ADDENDUM NO. 5

October 3, 2025

VALE FACILITY ADDITION/RENOVATIONS AND MAINTENANCE/IT FACILITY PROJECTS

Addendum Five (AD.05) to the drawings and specifications prepared by Gibraltar Design for **Valparaiso Vale Facility Addition/Renovations and Maintenance/It Facility and Related Work** for Valparaiso Community Schools, Valparaiso, Indiana.

C-104

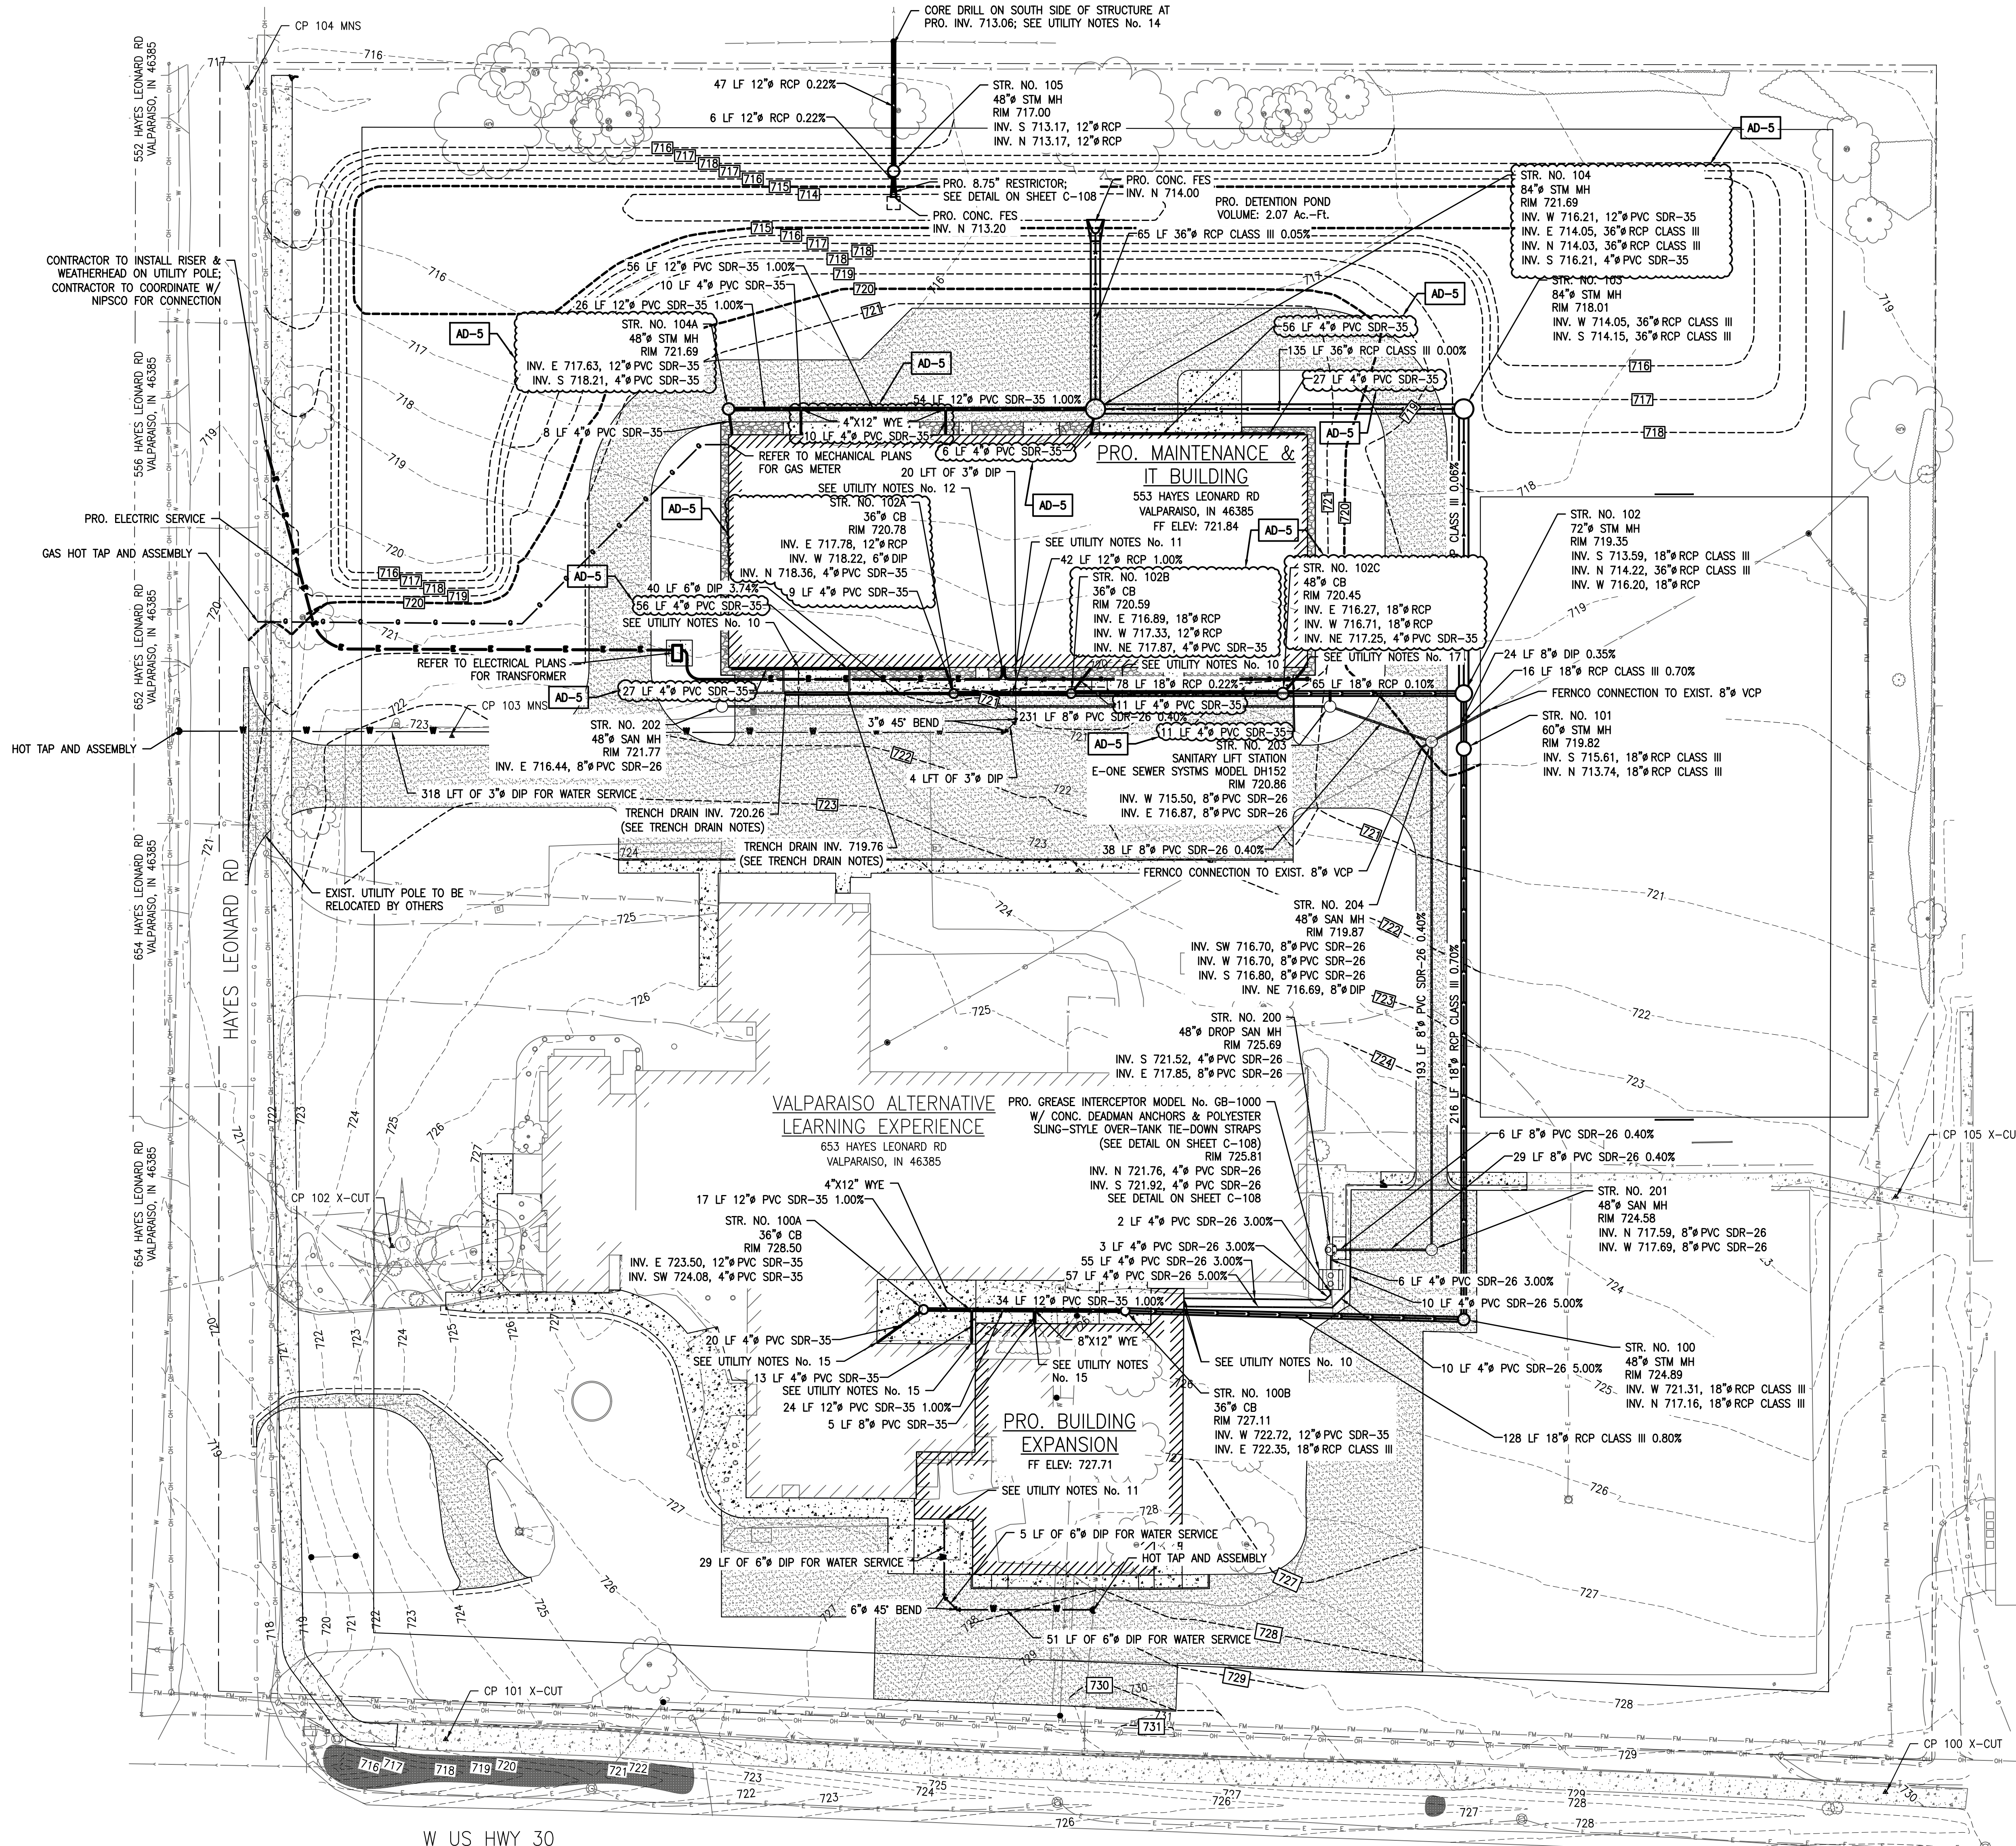
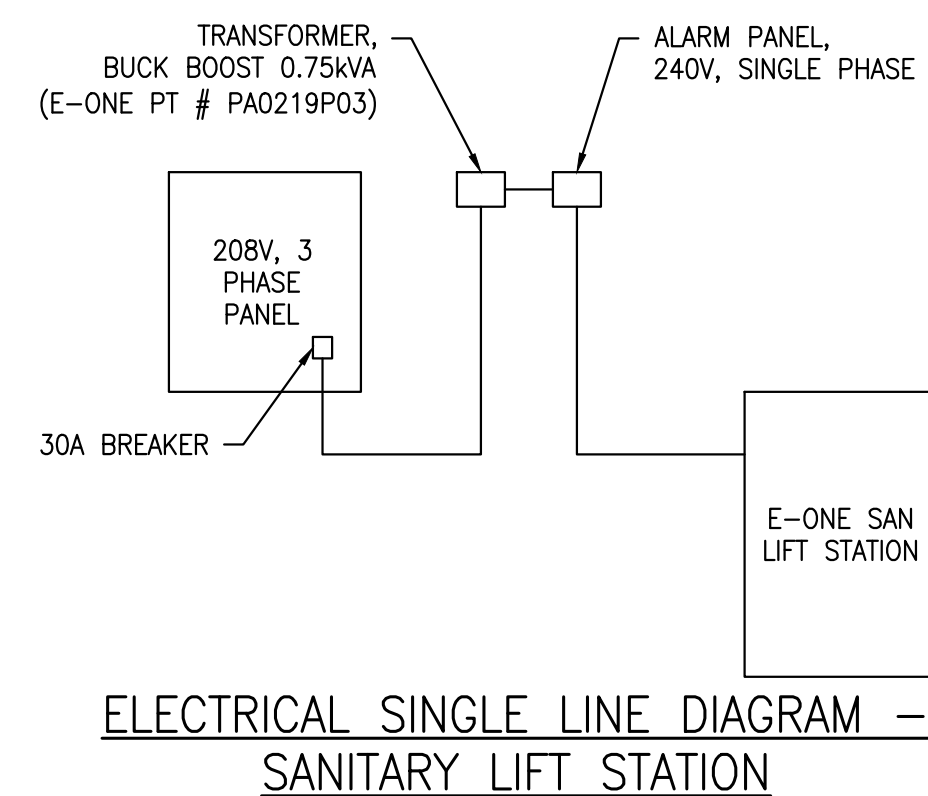
5. Sheet C-104

- Added 4" diameter downspout pipes coming from the Maintenance & IT building.
- Connected the 4" diameter downspout pipes to STR.'s 102A, 102B, 102C, 104, and 104A.
- Revised Utility Notes #15 by striking through "refer to plumbing plan sheets for downspout connections to building"; reference was not needed.

- ADDED 4" STM DOWNSPOUT PIPES COMING FROM THE MAINTENANCE/IT BUILDING.
- CONNECTED 4" STM DOWNSPOUT PIPE TO STR. 102A, 102B, 102C, 104, AND 104A.
- REVISED NOTE #15 IN UTILITY NOTES.

DRAWING
**TECHNOLOGY FIRST FLOOR
PLAN**

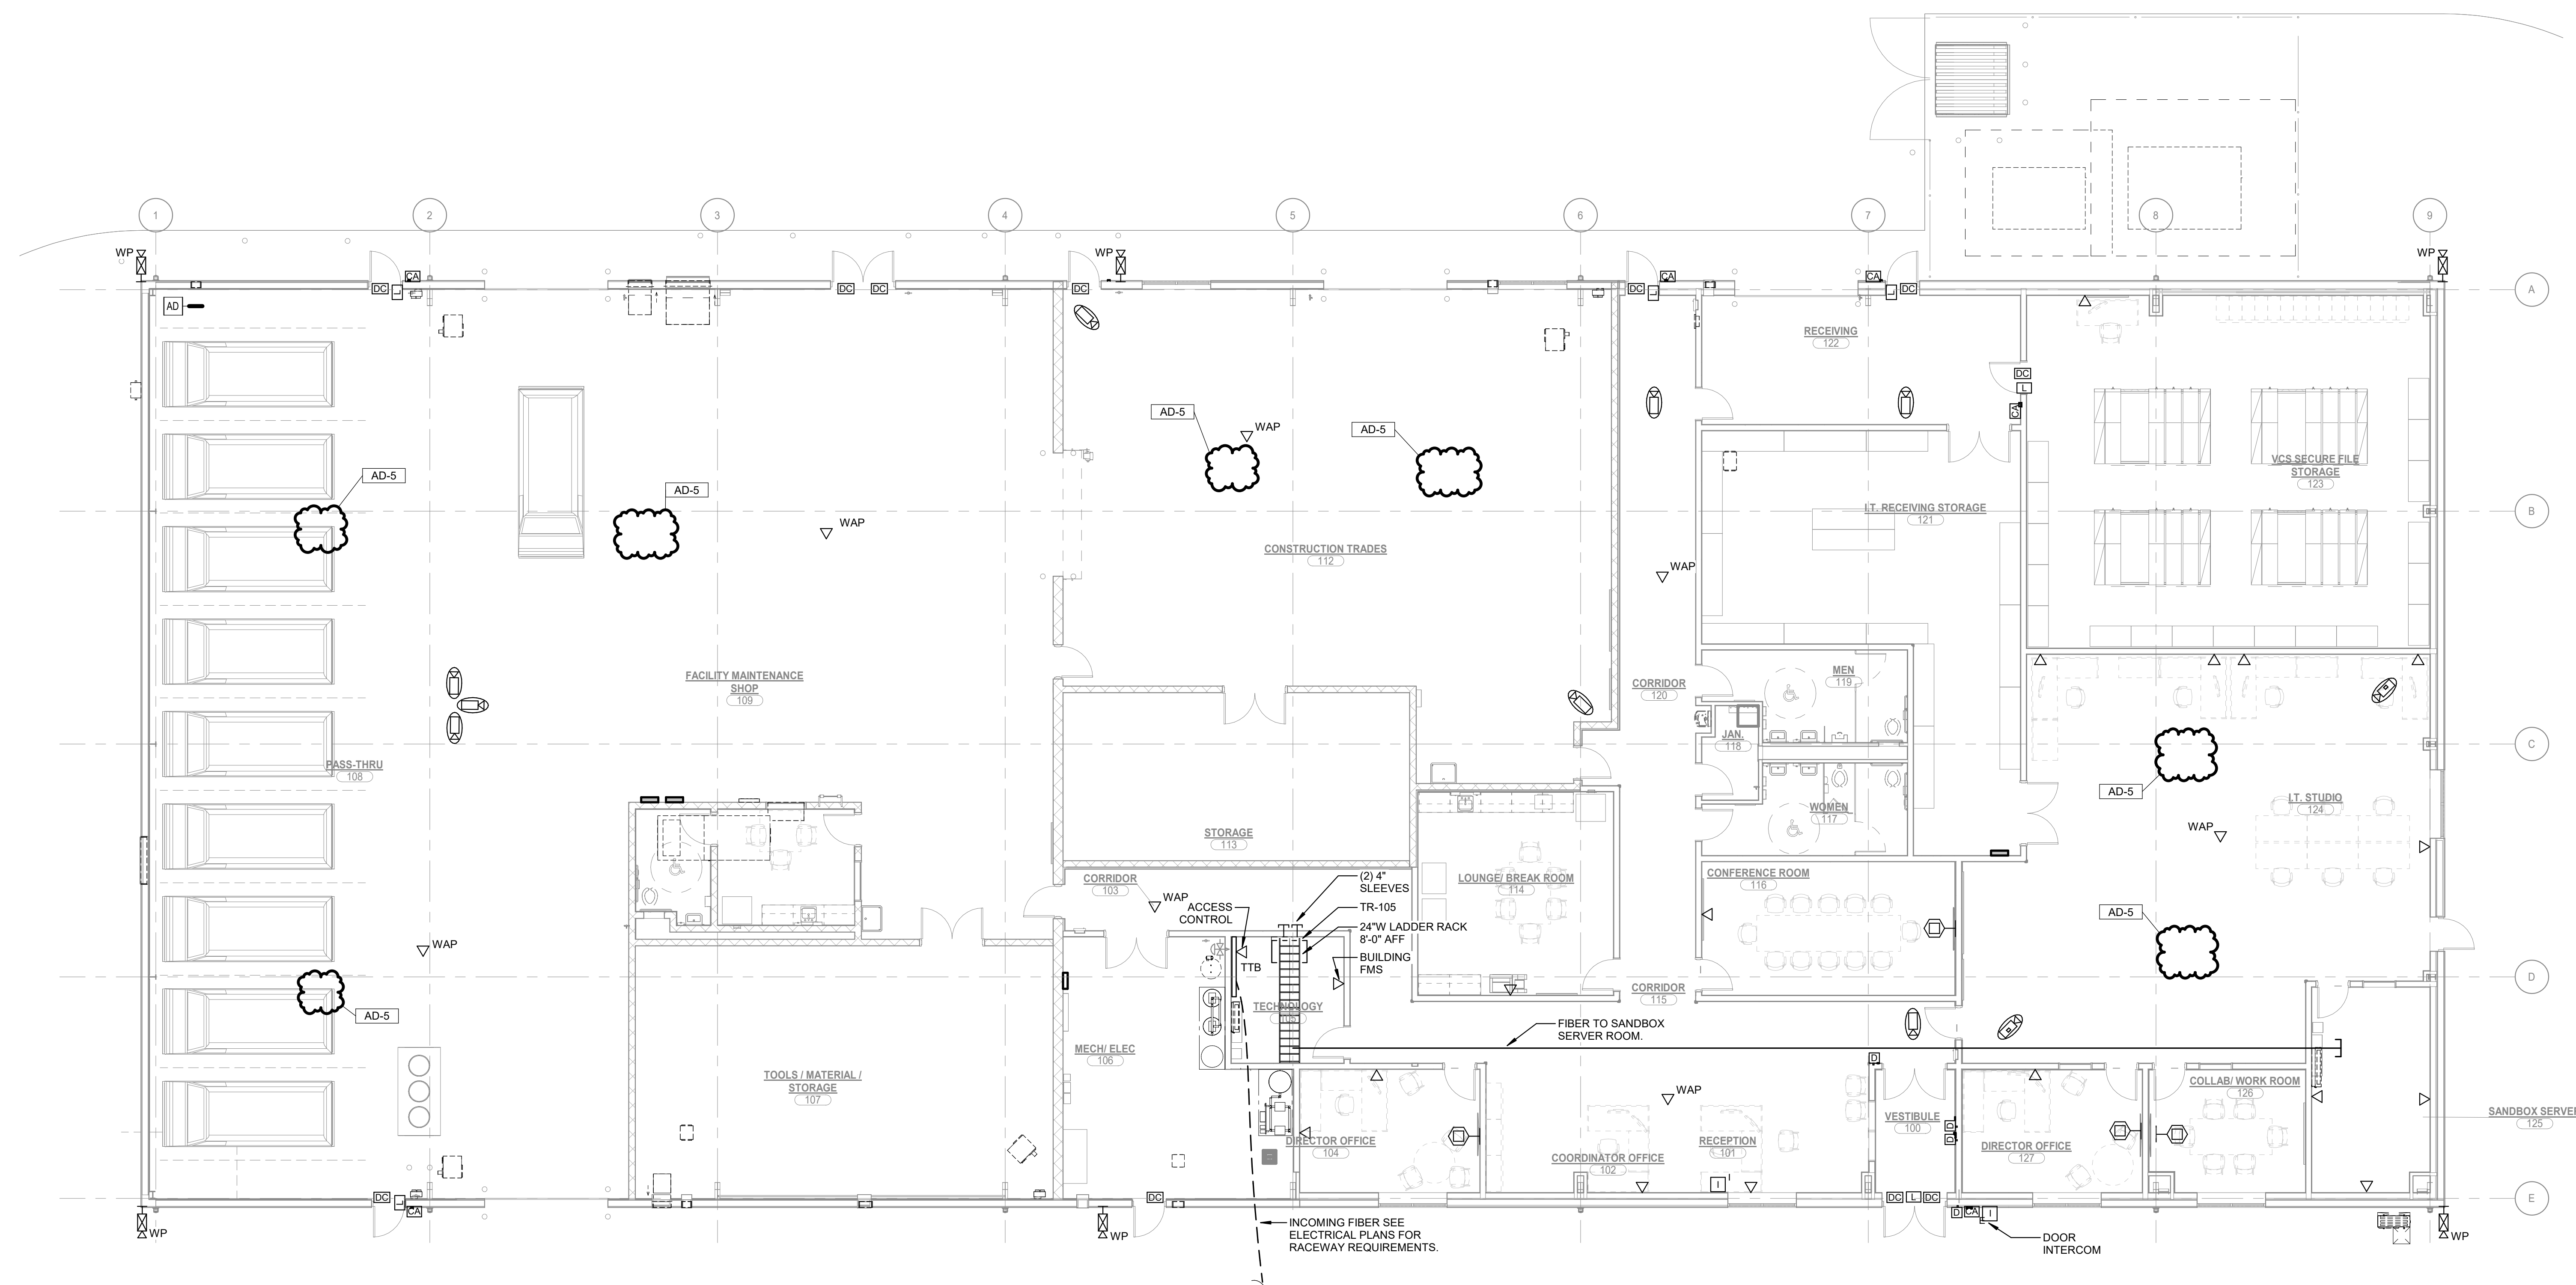
12. Sheet T-101

- A. Removed intercom equipment (speakers) from plan.
